Rockmart Public Works Facility

Project No. 2025-PW1

ADDENDUM No. 2

May 1, 2025

Exhibit A

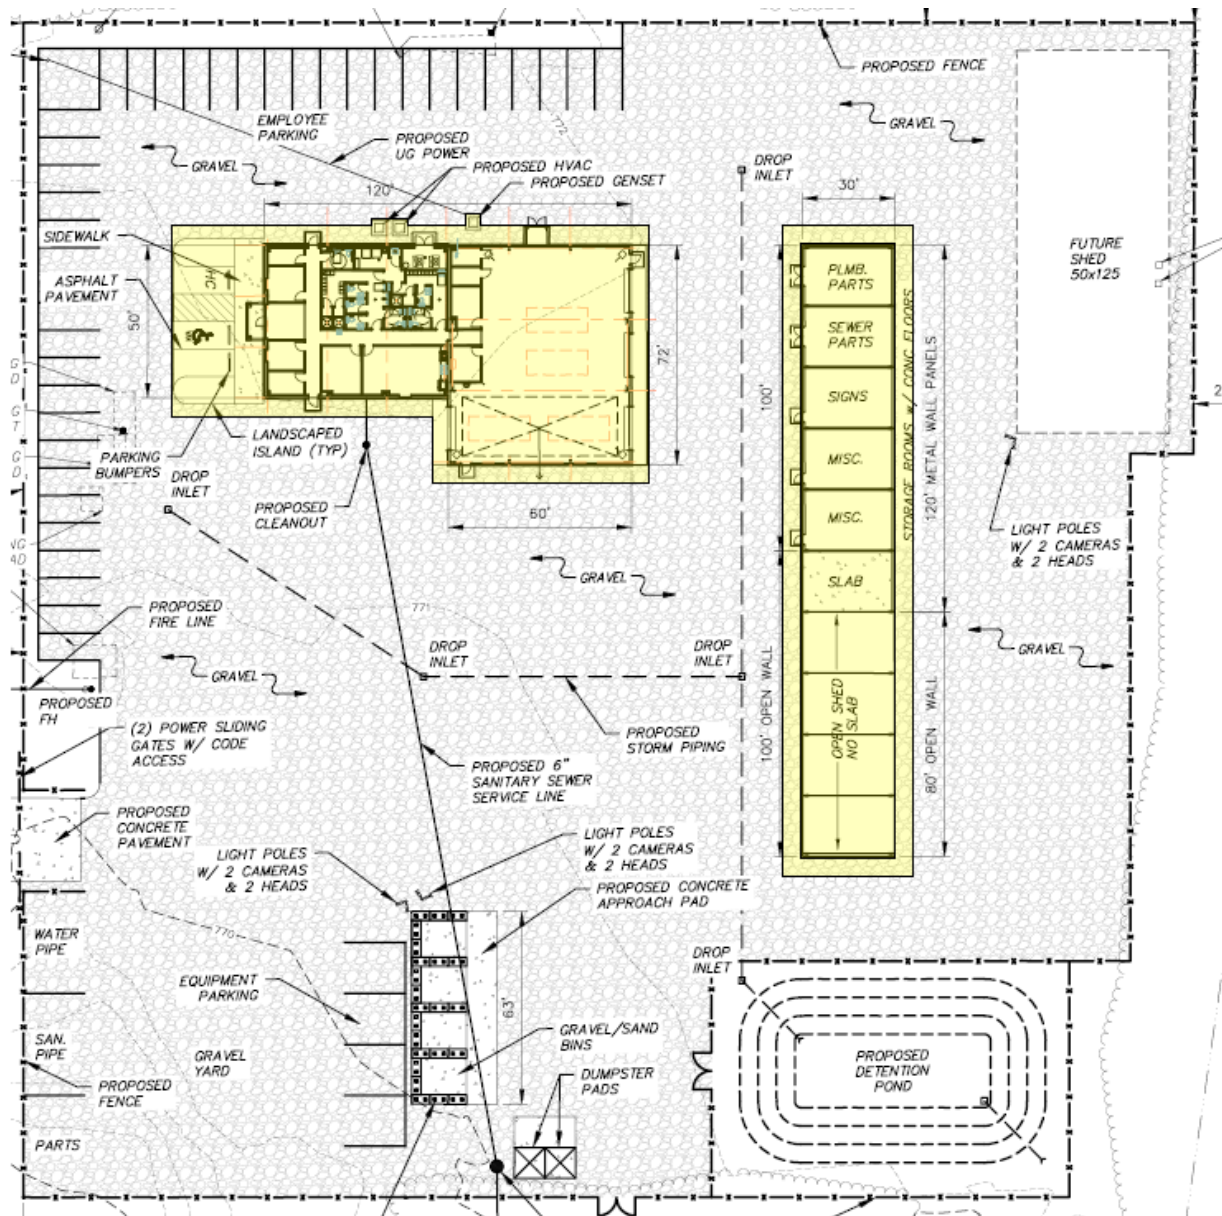
Is the owner or the GC responsible for the sitework on this project? **The building pad will be prepped and ready for foundation work by the owner. The General Contractor shall be responsible for carrying and connecting all utilities to within 6' of the building pad, as well as any and all pads associated with HVAC units, generators, landing pads at exit/entry doors, and sidewalks along the perimeter of the building. Additionally, the General Contractor shall be responsible for a small parking area shown on the western side at the front entrance and is to be included in the scope of work with the building. Please see the attached highlighted drawing that are incorporated in this addendum as "Exhibit A".**

Exhibit B

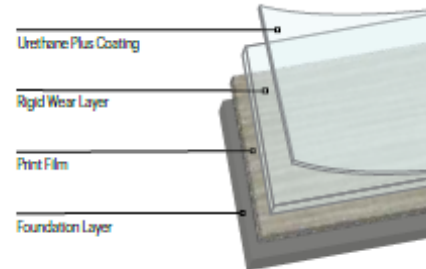
Please provide an allowance or a manufacturer, collection, and color for each flooring product. **Basis of Design for LVT: Armstrong, Solid Vinyl Tile/LVT, Parallel 20 USA, 6" x 48", Running Bond Pattern, Standard Colors (please see Exhibit B). Material Allowance for Floor Tile: \$8.00/sf. Contractor shall include in base bid, procurement, delivery, storage, tools and labor, and grouting.**
